**SUBJECT:** COMANCHE PEAK STEAM ELECTRIC STATION  
DOCKET NOS. 50-445 AND 50-446  
SUPPLEMENT TO LICENSE AMENDMENT REQUEST (LAR) 07-004  
REVISION TO THE OPERATING LICENSE AND TECHNICAL SPECIFICATION 1.0,  
"USE AND APPLICATION" TO REVISE RATED THERMAL POWER FROM 3458 MWT  
TO 3612 MWT. (TAC NOS. MD6615, MD6616, MD8417 AND MD8418)

Attachment Response to Request for Additional Information

RESPONSE TO REQUEST FOR ADDITIONAL INFORMATION  
COMANCHE PEAK STEAM ELECTRIC STATION STRETCH POWER UPRATE

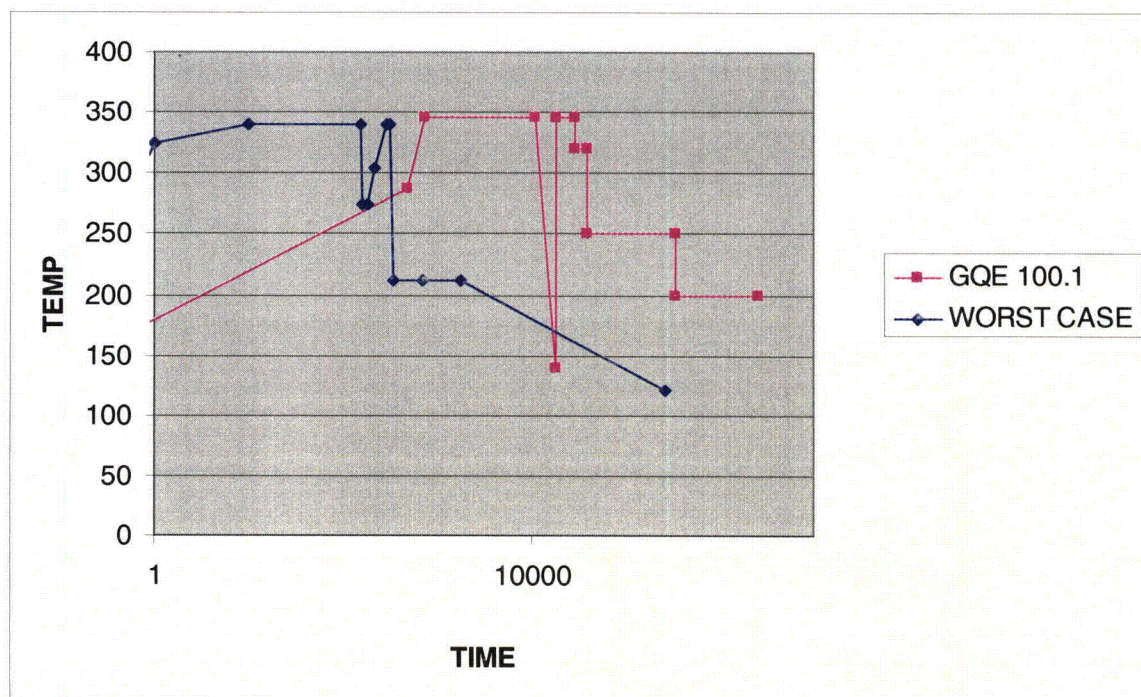
The following is a comparison of the SPU HELB profile to the profile used to qualify ASCO valves using EPDM elastomers in AQS21678/TR:

While the ramp time of test report number AQS21678/TR is longer than that of the required profile, the duration of the peak temperature was much longer than required. Also the test from test report number AQR67368 contained both Viton and EPDM elastomers and showed that there is no failure due to high temperature or a steep ramp. Therefore, the long ramp of test report number AQS21678/TR will have no adverse impact on the qualification of the valves.

The test report number AQS21678/TR did not attain the recommended 15°F margin on temperature. This condition is acceptable based on the following:

- 1) The test attained a temperature of 346°F for three hours, while the requirement is 340°F for 175 seconds.
- 2) The test included two transients to 346°F each of which maintained 346°F for 10,000 seconds.
- 3) Test report number AQR67368 demonstrated a maximum temperature of 450°F. This test included EPDM and Viton elastomers.

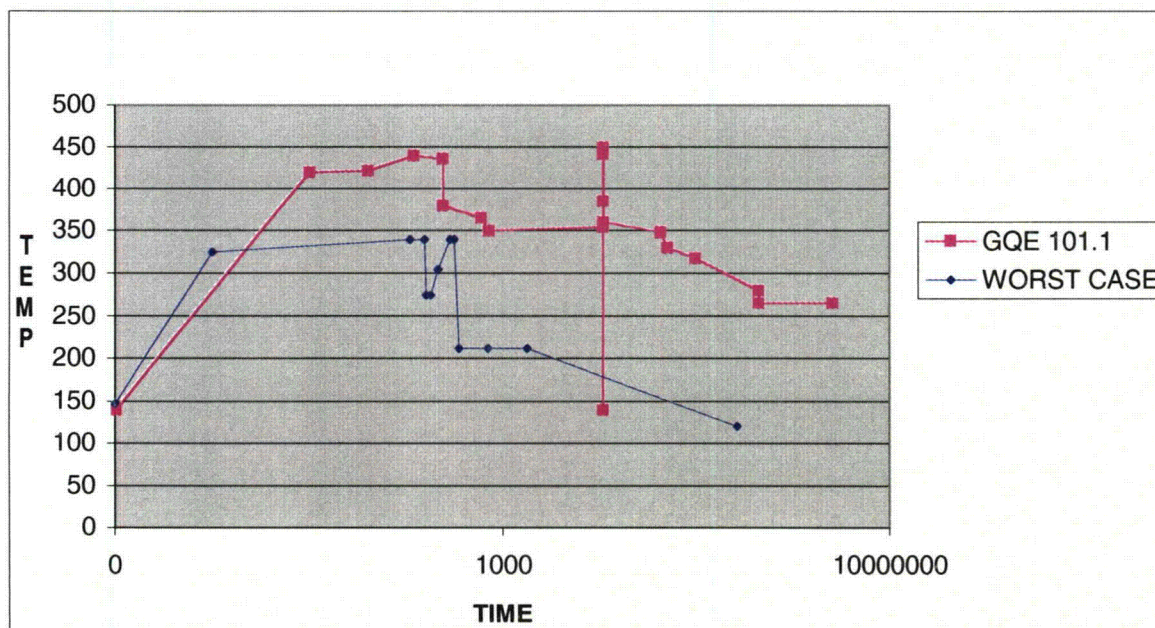
The following is a comparison of the SPU HELB profile used to qualify ASCO valves using Viton elastomers in AQR-67368:

The ramp time of the required profile is steeper than the test profile. However, the peak temperature exceeds the required temperature by more than 110°F. The required profile is bounded by the test profile. The required 15°F margin is satisfied.

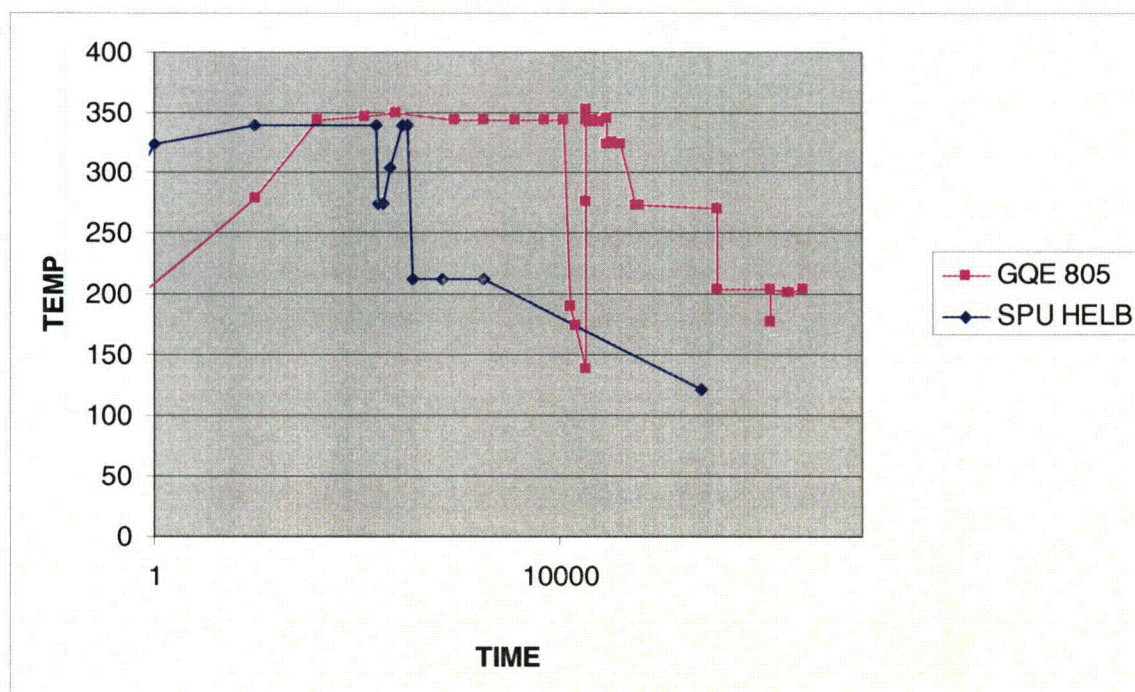
The following is a comparison of the tested and required SPU profiles:

The ramp time of test report number QTR-142 is longer than that of the required profile, and the test profile did not attain the recommended 15°F margin on temperature. This condition is acceptable based on the following:

- 1) The tested profile was a two transient test. The first transient reached a peak temperature of 350°F, while the second transient reached a peak temperature of 353°F.
- 2) Each of the two transients was maintained for 10,760 seconds.
- 3) During the first 3 hour transient, the temperature did not drop below 344°F, and during the second transient the temperature did not drop below 343°F.

Margin is demonstrated by the time at temperature of the test specimens. The required peak temperature is 340°F for 175 seconds. The test specimens were exposed to over 21,500 seconds at temperatures that exceeded 343°F.

**Figure 1**

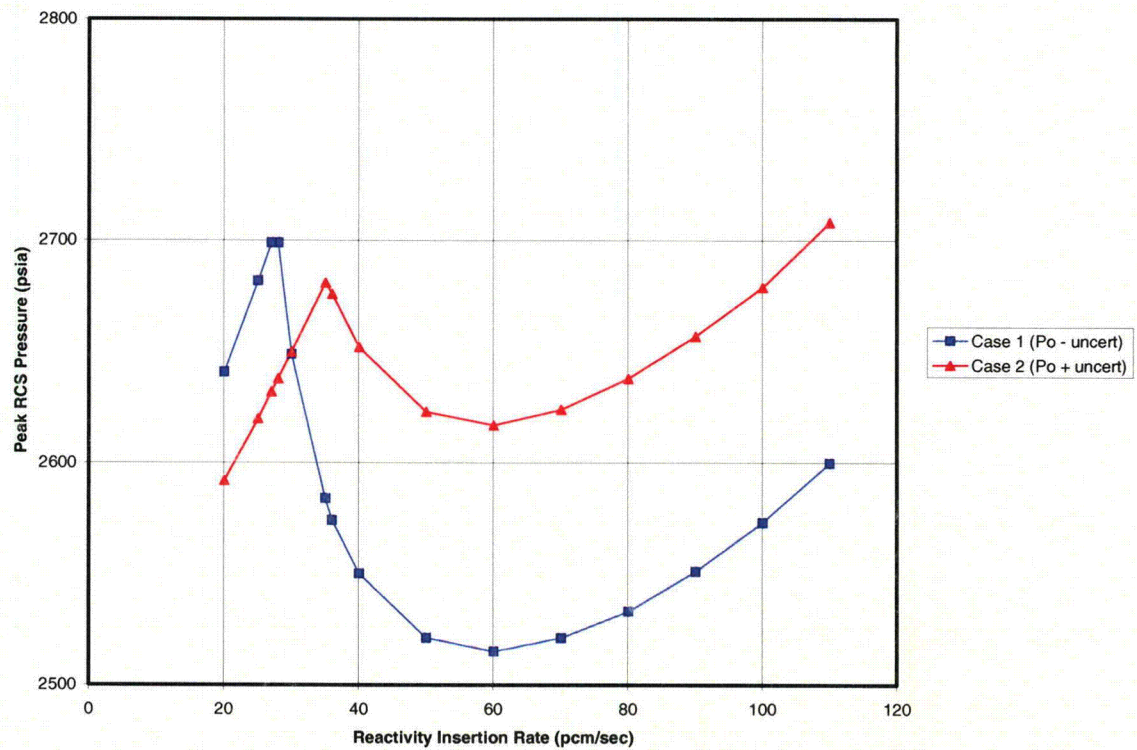
Figure 1 shows trends of the calculated peak RCS pressure results versus reactivity insertion rate for the two generic cases that resulted in the maximum RCS pressures without taking credit for the PFRT. Case 1 assumes the minimum initial pressurizer pressure of 2200 psia, while Case 2 assumes the maximum initial pressurizer pressure of 2300 psia. What is important to observe in Figure 1 is that although the high pressurizer pressure reactor trip can be actuated in time to protect against exceeding the RCS pressure limit (2748.2 psia) for lower reactivity insertion rates, it is insufficient for higher reactivity insertion rates. For low reactivity insertion rates, the nuclear power and RCS temperature increase relatively slowly, such that the main steam safety valves (MSSVs) are able to open and limit the primary-to-secondary power mismatch until the reactor trip is actuated. At greater reactivity insertion rates, the reactor power begins increasing faster than the primary system can transfer the heat to the secondary,

and the power mismatch continues to increase until the reactor trip occurs and the control rods insert into the core. Without the PFRT, the maximum reactivity insertion rate would need to be limited to a fairly low value.

**Figure 2**  
Westinghouse Generic RWAP Analysis  
Peak RCS Pressure Results with PFRT

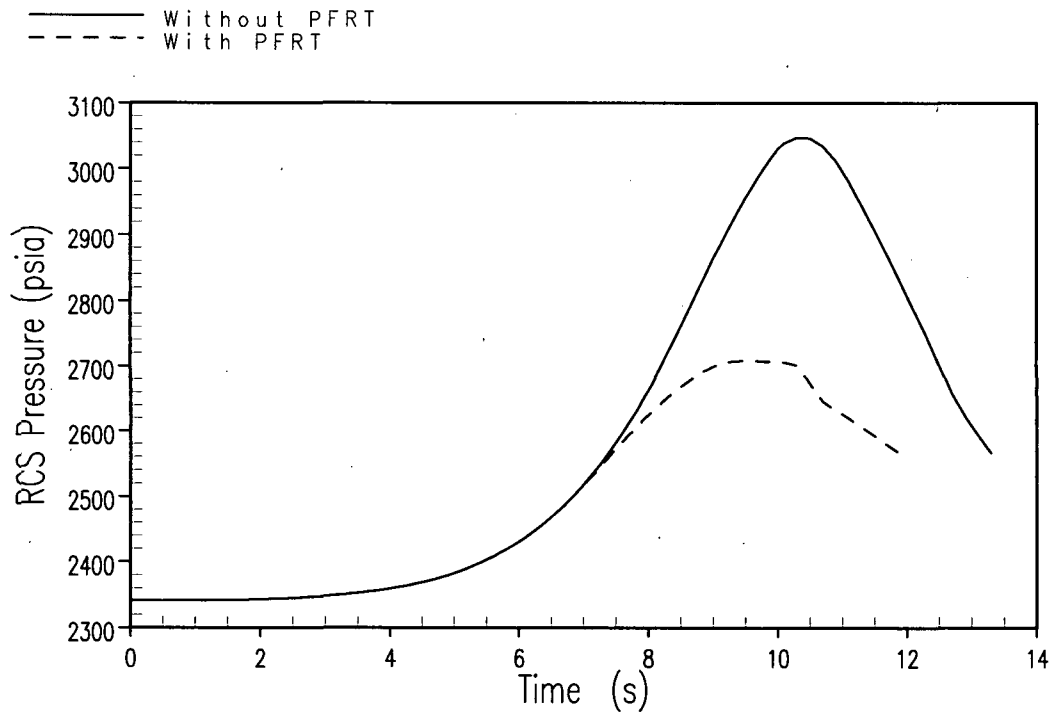
Figure 2 shows trends of the calculated peak RCS pressure results versus reactivity insertion rate for the same two limiting RCS pressure cases with credit taken for the PFRT. Table 1 lists the time sequence of events for the Case 2 (2300 psia initial pressurizer pressure) characteristic small, intermediate, and large reactivity insertion rate results, with the PFRT function credited for mitigation. For the small reactivity insertion rate, the power increases slowly enough such that the PFRT is not generated. Similar to the results shown in Figure 1, Figure 2 shows that for lower reactivity insertion rates, the HPPT is actuated in time to limit the power mismatch and to keep the RCS pressure below the limit. As the reactivity insertion rate increases to 25-35 pcm/second (depending on the Case), the resultant increase in reactor power becomes rapid enough to actuate the PFRT. As the reactivity insertion rate becomes larger, the PFRT is actuated earlier in the RWAP event. Up to a point after the PFRT comes into play (~60 pcm/second), the effect of tripping the reactor earlier outweighs the effect of an increase in the reactivity insertion rate, and the RCS pressure response becomes less limiting. Beyond this point, the peak RCS pressure becomes more limiting with each increase in reactivity insertion rate, despite an earlier reactor trip. Based on the results presented in Figure 2, the combination of HPPT and PFRT provides adequate protection for a bounding range of reactivity insertion rates to ensure that the RWAP event does not result in an RCS pressure that exceeds the limit.
